IFB SA 2409 Wellington Road Operations Center Expansion

**Addendum #3**

## **IFB SA 2409 Wellington Road Operations Center Expansion Addendum #3**

### **Questions and Responses**

PLAN DATE: OCTOBER 7, 2022  
DESIGN BY: AG/SAW  
CHECKED BY: SSD  
ARCHITECT/MOSELEY ARCH  
JURISDICTIONAL PLAN NO. SPR2023-00185  
RDA PLAN #: 19001-008  
SHEET NUMBER: C.13

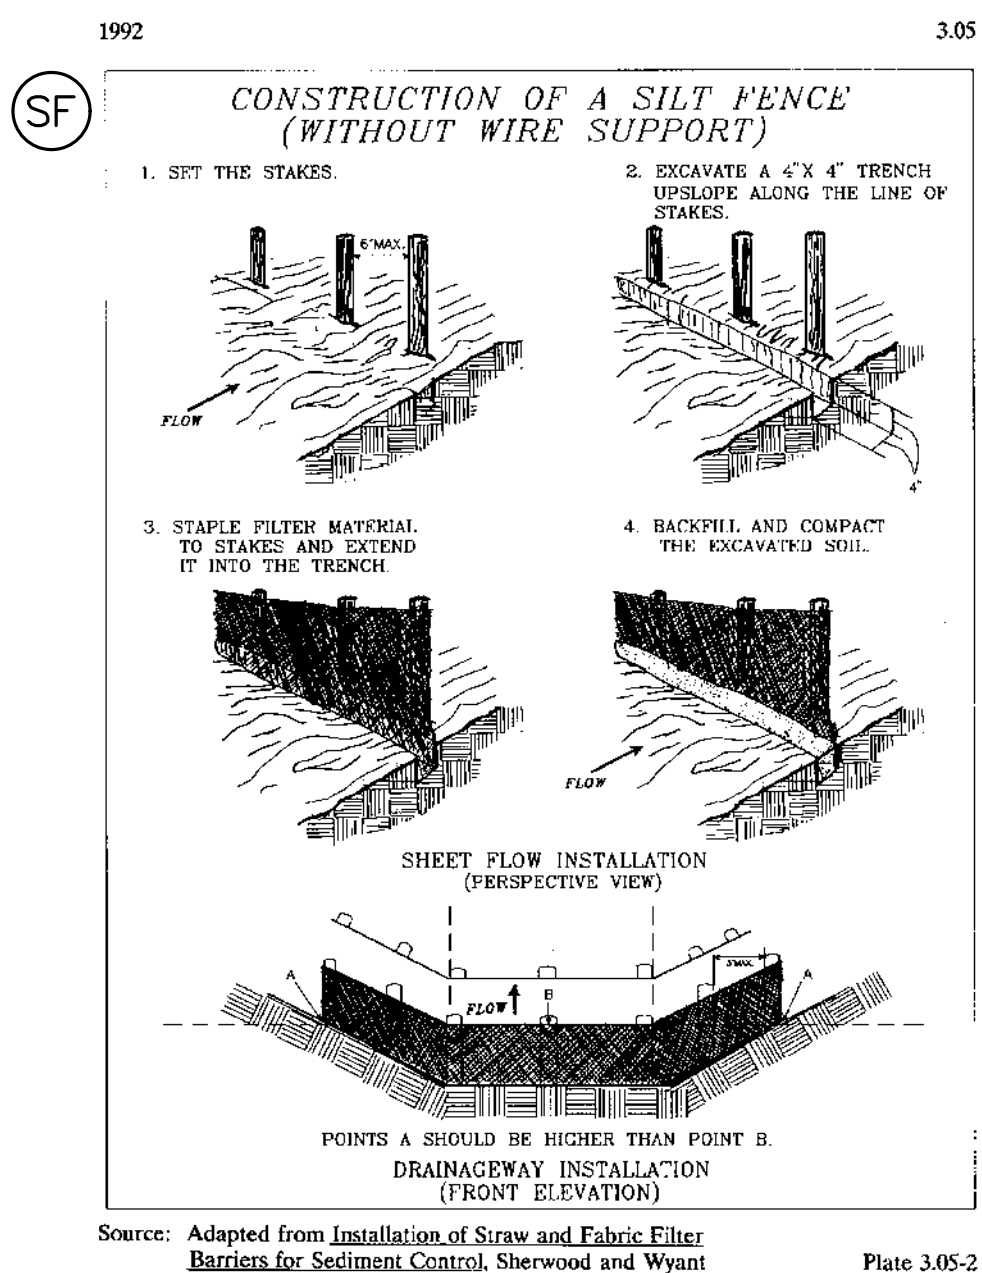
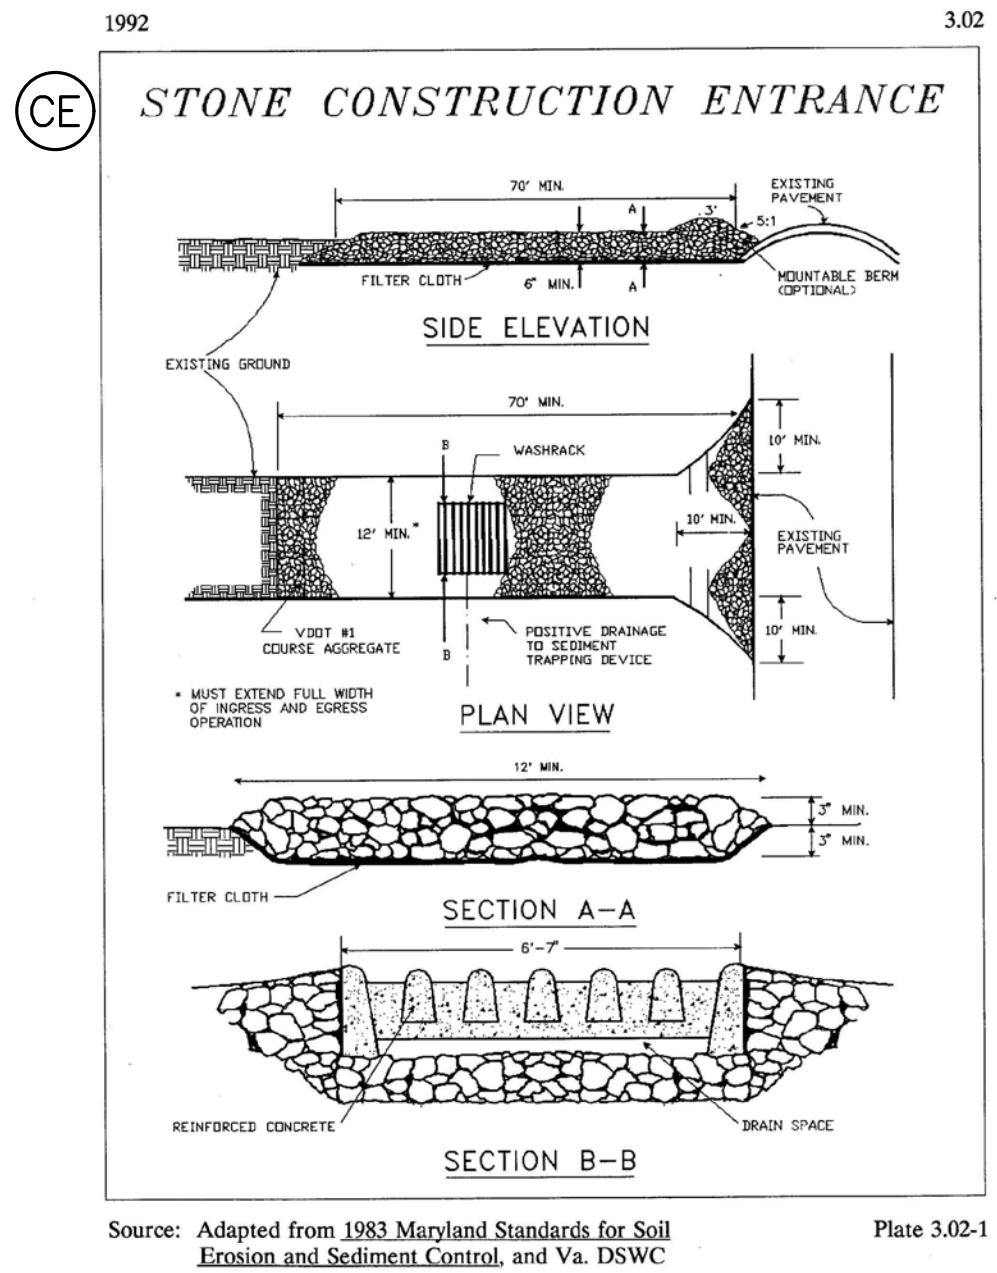
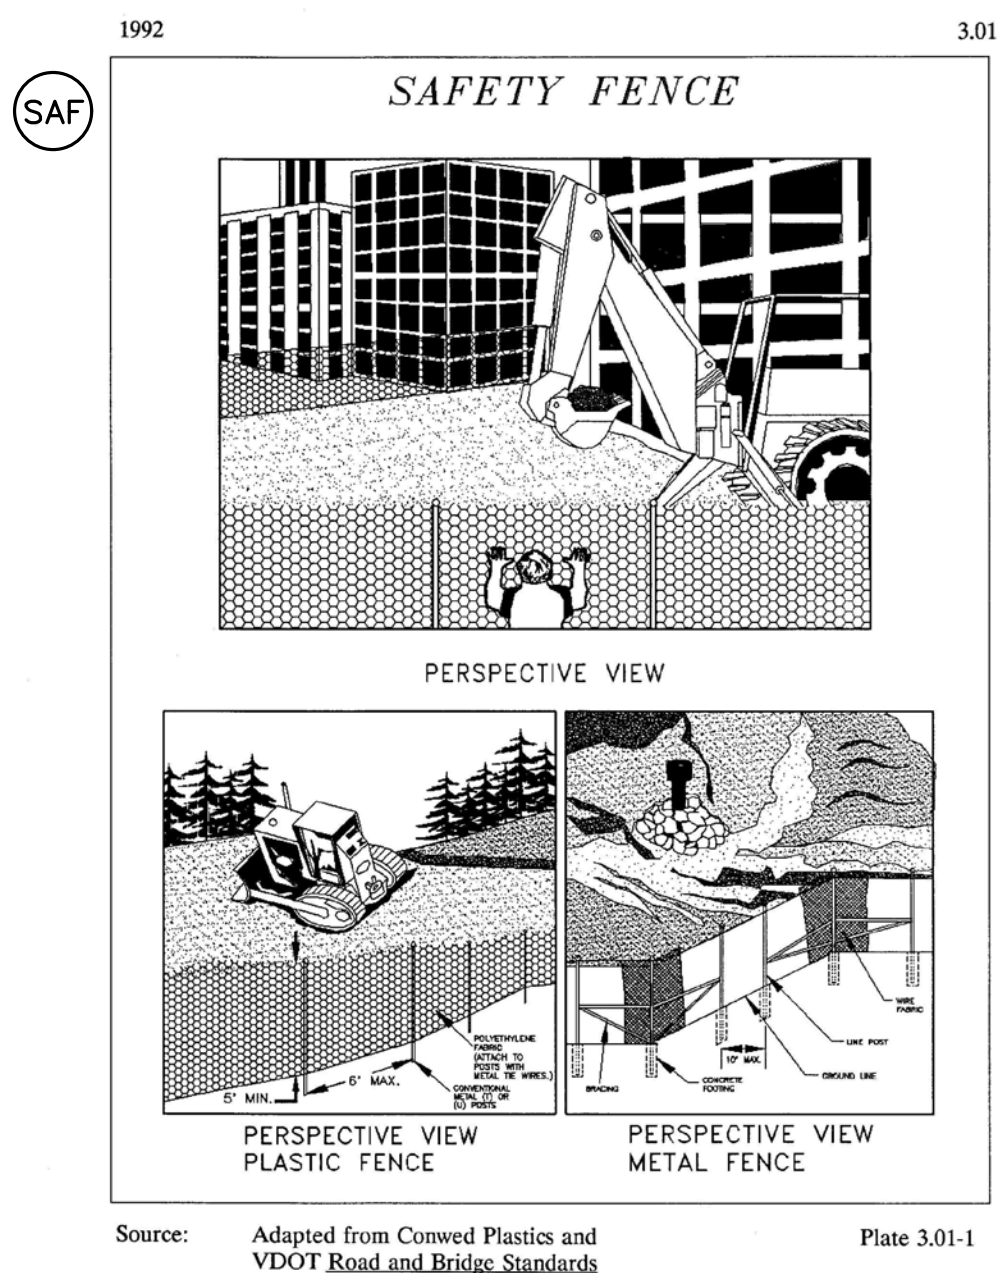
**33. Question:** Reference drawings C.04 and C.13. On C.04, part of the existing parking lot looks like it should be replaced with heavy duty asphalt per drawing C.13. This portion of the existing parking lot is not shown as being removed/replaced on C.04. Please clarify.

**47. Question:** On drawing C.05, there is a label on the drawing for CG-2. It is outside of the Operations Center by the FDC. What is this for? Is it a type of curb & gutter? I only saw CG-6 and CG-6R for the curb & gutter types.

**Response:** The southwest portion of the parking lot near the existing entrance is to be mill and overlay only as shown on sheet C.13. The rest of the parking lot pavement shall be removed, regraded, and replaced.

**Response:** CG-2 is a type of curb. See VDOT Road and Bridge Standards, latest edition. A detail has been added to the plan. See Sheet C.13.

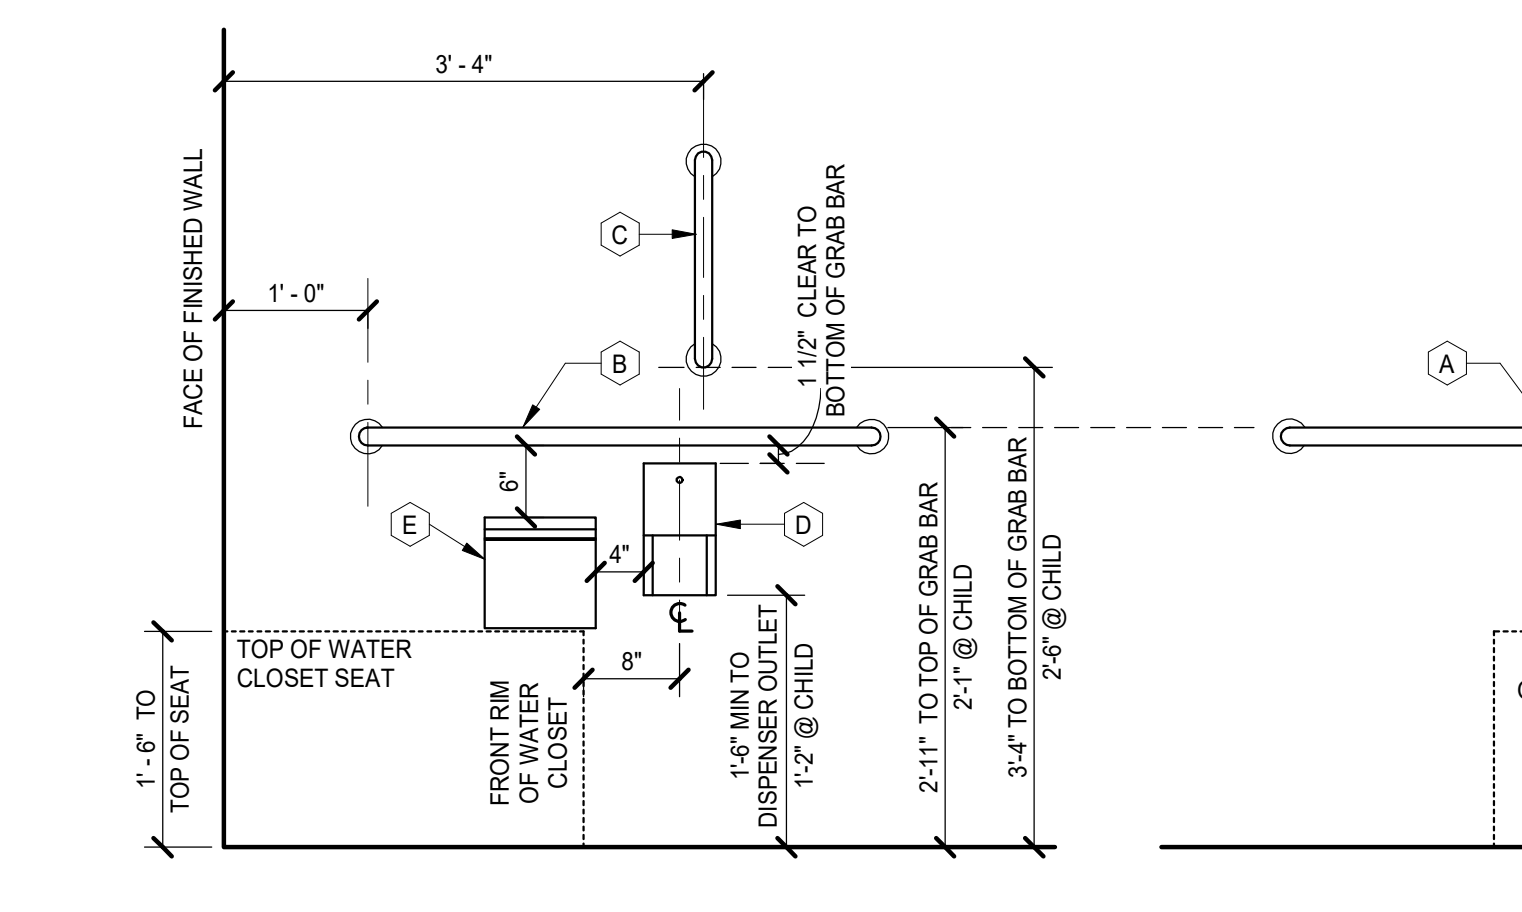
**43. Question:** Reference drawing A2.1.3. Are the shower curtains to be furnished and installed by the owner or the general contractor? They are not listed in the Toilet Accessories Schedule, but they are shown on 3/A2.1.3. Please clarify.

**Response:** Yes, by the GC as indicated in Note 7 of the Toilet Accessory Schedule.

**4 NORTH ELEVATION**  
 A2.1.1/A4.1.1 1/8" = 1'-0"

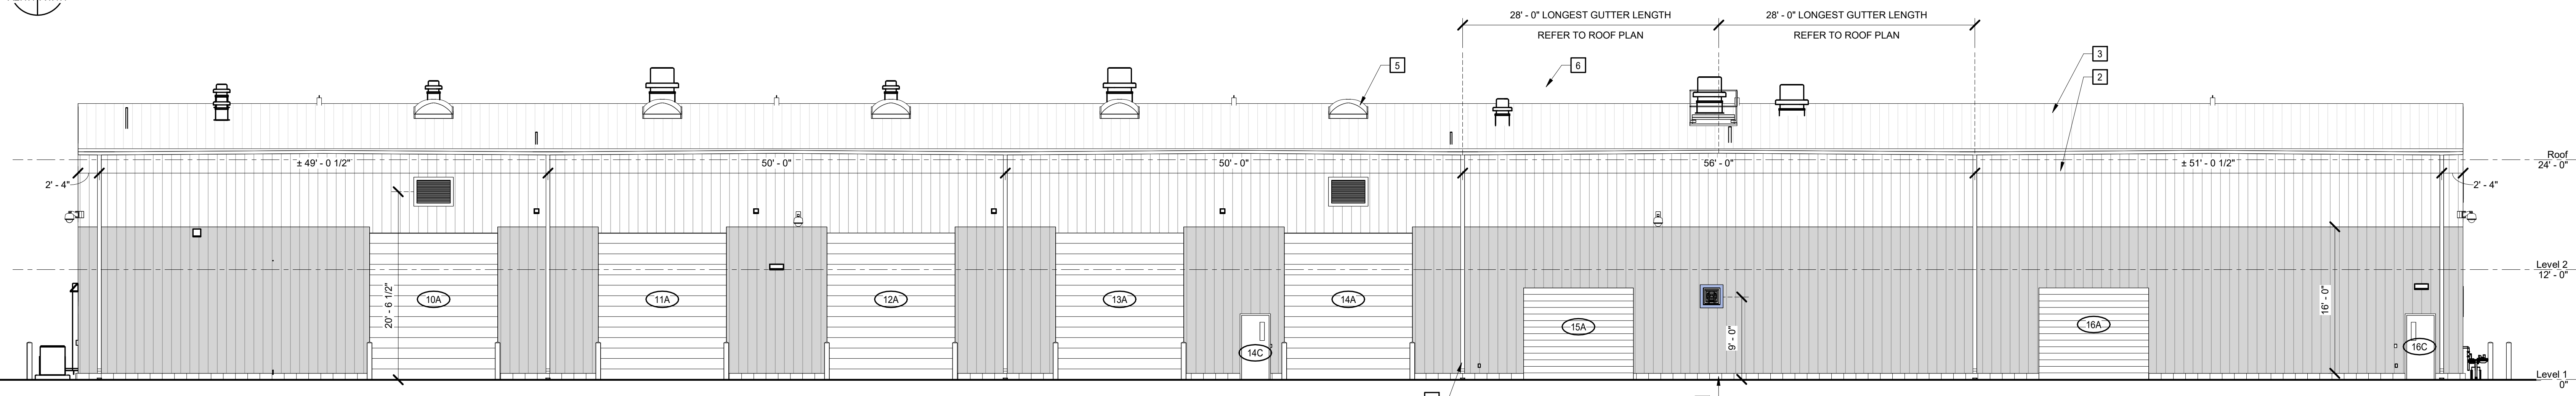
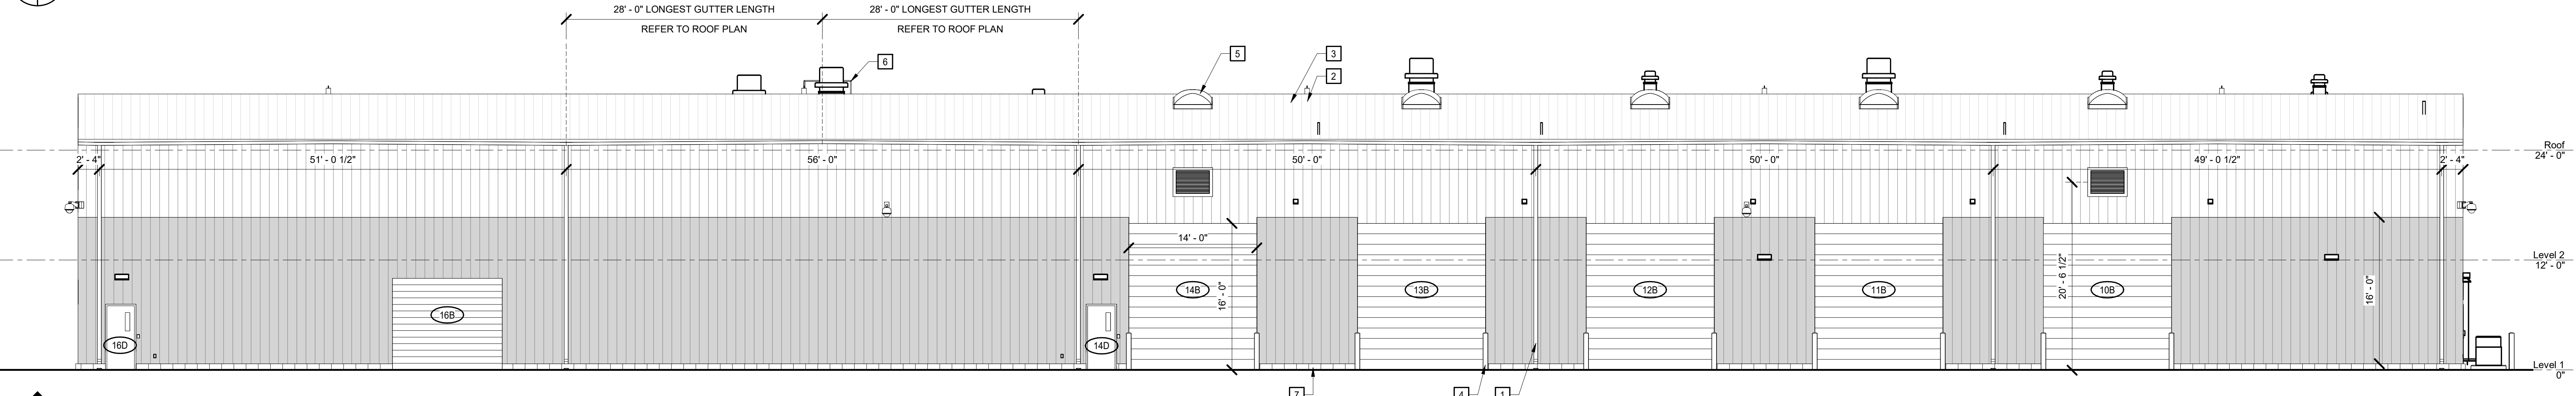
**16. Question:** Drawing A4.1.1 refers to Wall type W3. No W3 was found in plans/sections. Please clarify.

**Response:** W3 is shown on Building Section 5/A2.1.4.

PLAN DATE:	7/11/23
DESIGN BY:	JH/MC
CHECKED BY:	SDD
ARCHITECT:	
JURISDICTIONAL PLAN NO.	
RDA PLAN NO.19001-016	
SHEET NUMBER:	C.03

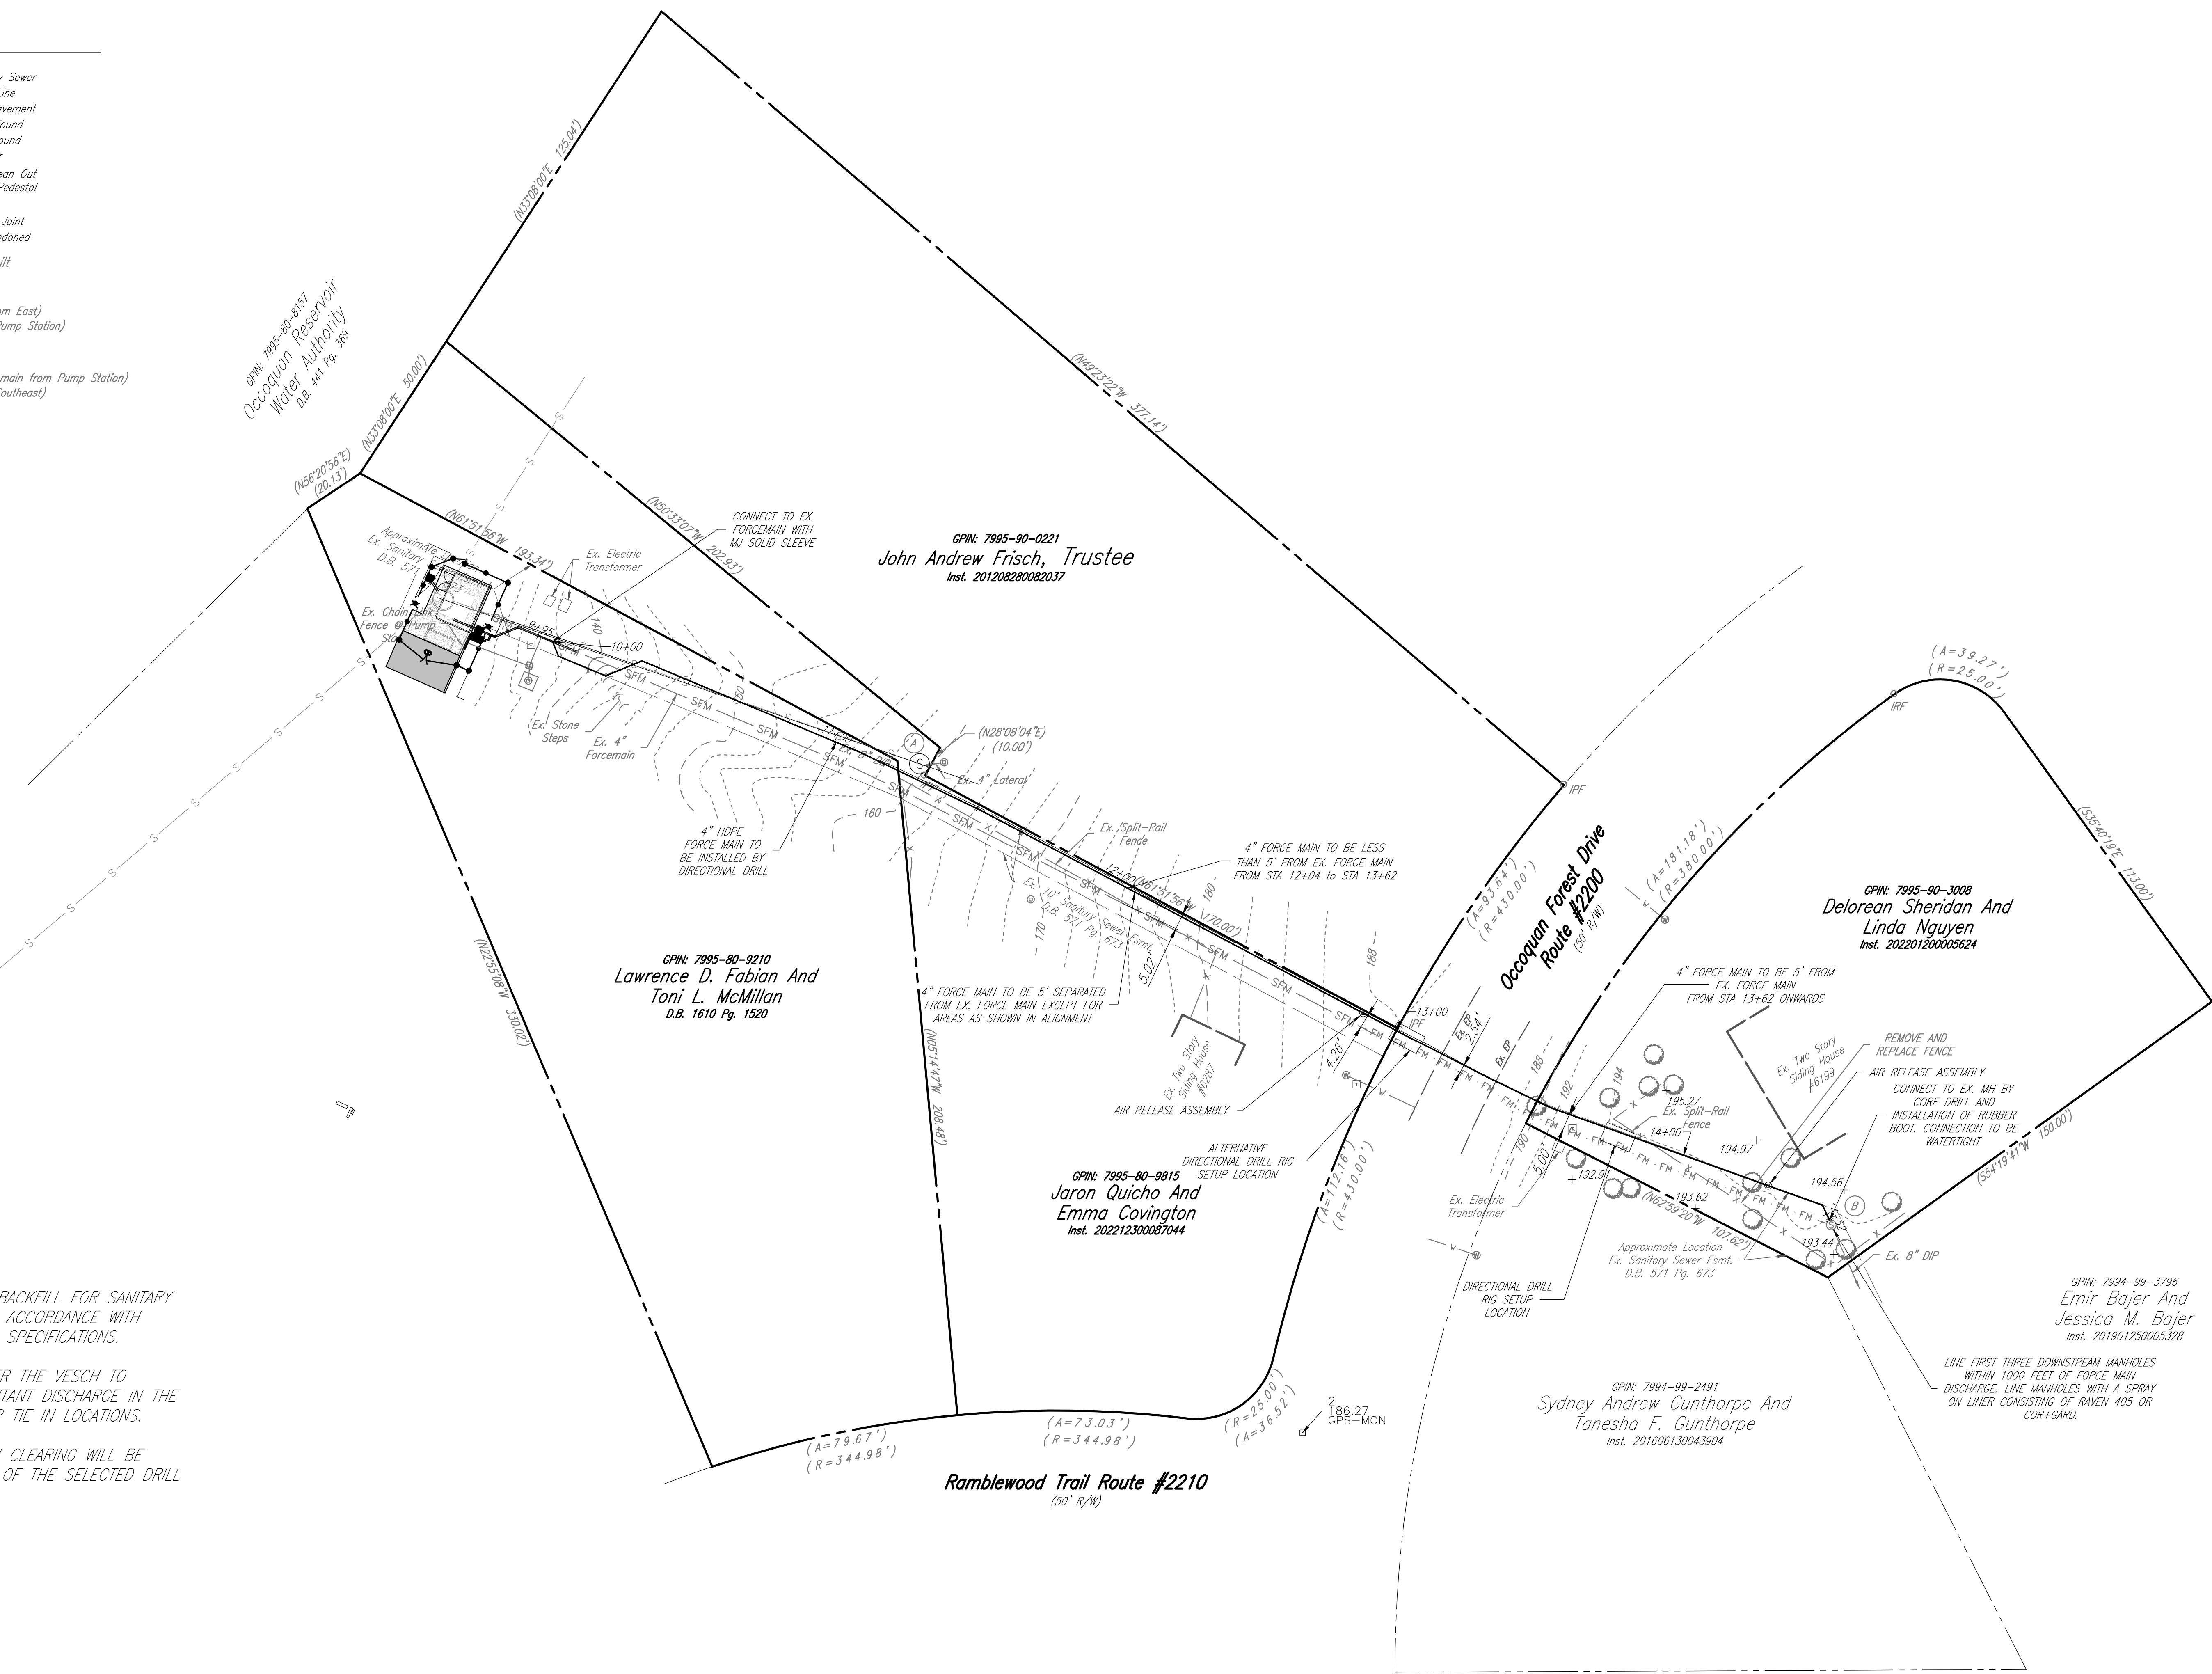
**22. Question:** Please refer to Drawing Number C.03, Sanitary Sewer Plan for Occoquan Pump Station 37 Force Main. We understand this is not in the scope of work of the Wellington Road Operations Center Expansion. Please confirm.

**46. Question:** There is a 2<sup>nd</sup> drawing labeled C.03 that is not for this project. It is for project called, "Occoquan Pump Station 37." Please delete this drawing.

**Response:** Correct. Drawing Number C.03 Sanitary Sewer Plan for Occoquan Pump Station 37 Force Main is not part of the scope of work.

**Response:** Drawing Number C.03 Sanitary Sewer Plan for Occoquan Pump Station 37 Force Main is not part of the scope of work.
